PETITION EXHIBIT 22

3 December, 2007

RE: COMMENTS ON DRAFT CLEANUP AND ABATEMENT ORDER NO. R3-2007-0077 TO OLIN CORPORATION, 425 TENNANT AVENUE, MORGAN HILL, CALIFORNIA

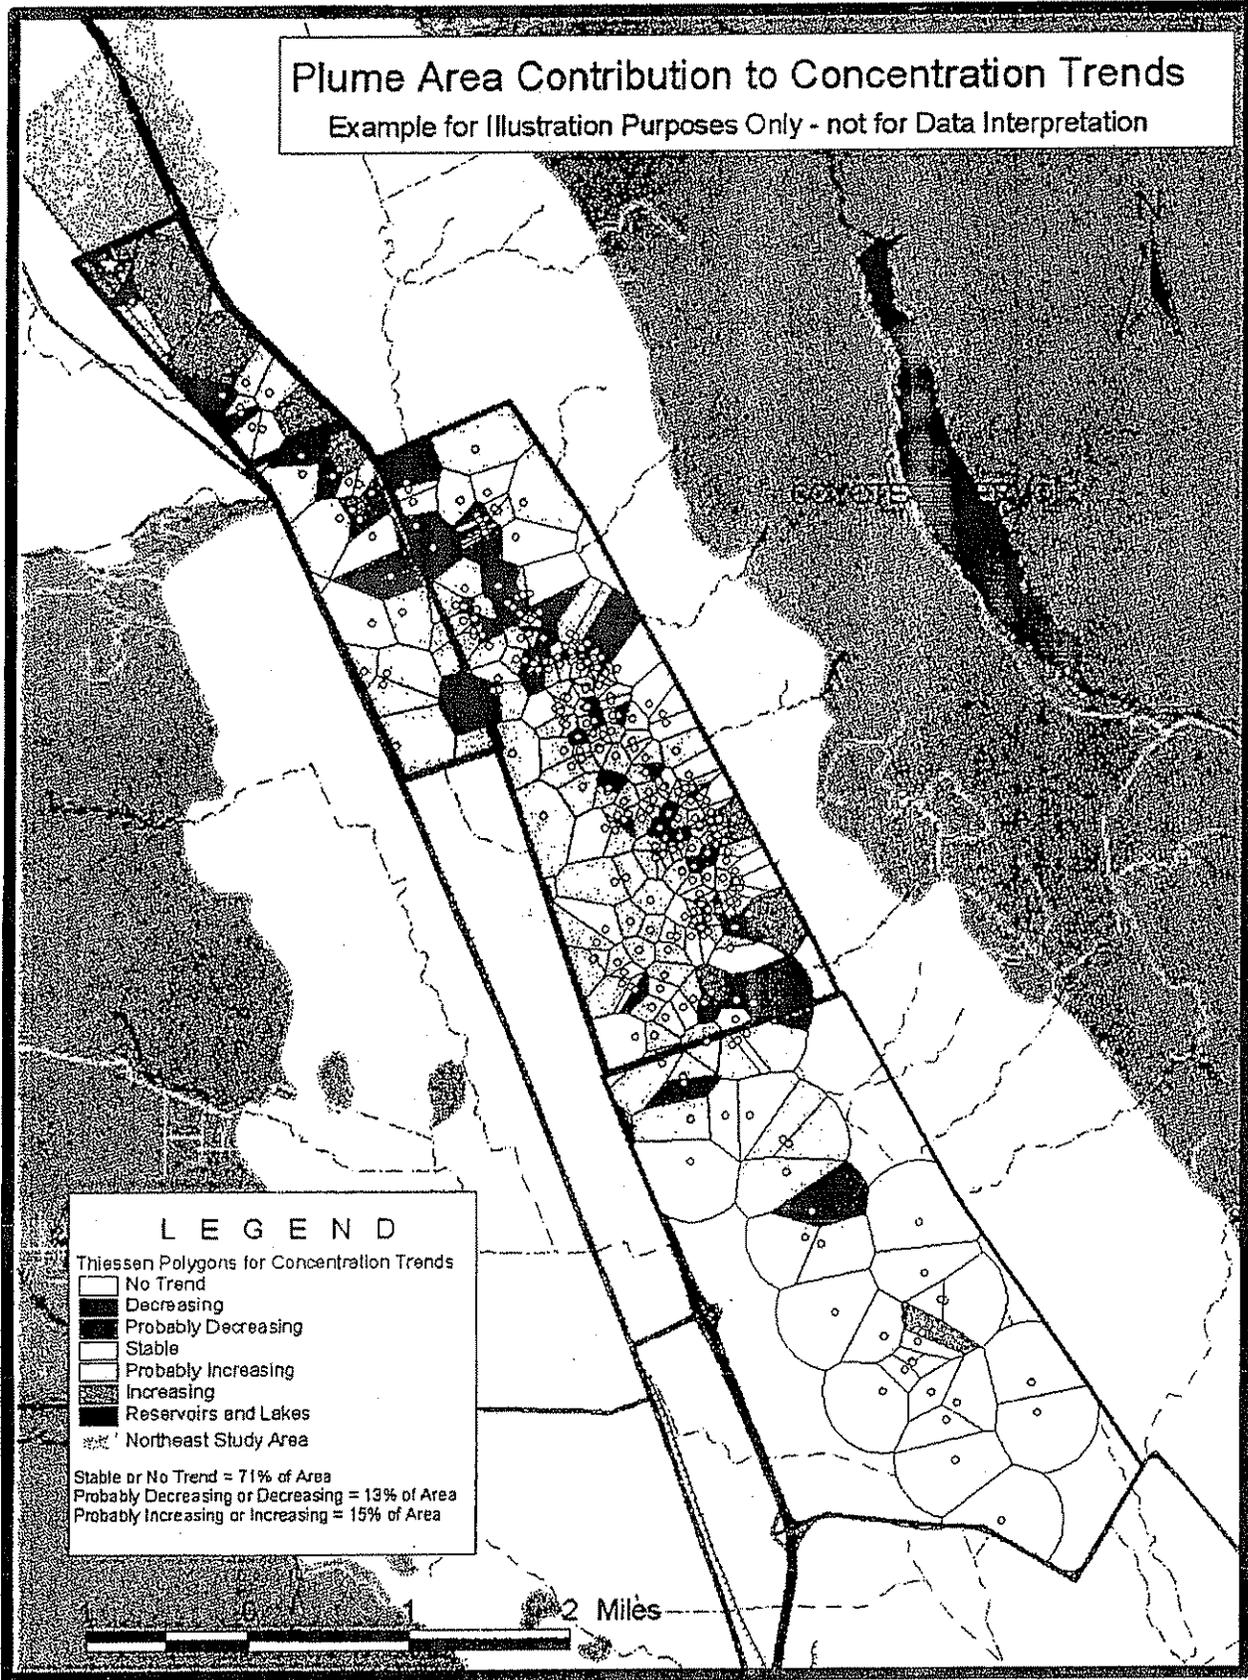
A review of the map reveals that counting a group of wells that are spaced close together and apparently decreasing should not carry the same weight as wells spaced further apart. If the data are "declustered", a different picture emerges (see Figure below.) In the declustered data for the Second Quarter Monitoring Report, the majority of wells have stable trends or no discernible trends, as was found by counting the raw data. However, when accounting for area, perchlorate concentrations in approximately 13% of wells in the declustered data are decreasing, while concentrations in approximately 15 % of the wells in the declustered data are increasing

For illustration purposes, the Figure below presents a simplistic method to decluster the data using Thiessen Polygons.³ This allows viewing the trends by the number of acres represented by each well for which trend analysis was executed by Olin.

This example does not account for variations in depth, pumping, concentration range, or statistical features; nor does it present an error-free or complete analysis. However, this alternative way to view the trends suggests that Olin's practice of counting wells without consideration of area may introduces a significant bias.

Recommendation: The Water Board should consider directing Olin to present the concentration trend data for purposes of plume analysis in a manner that accounts for the effects of data clustering.
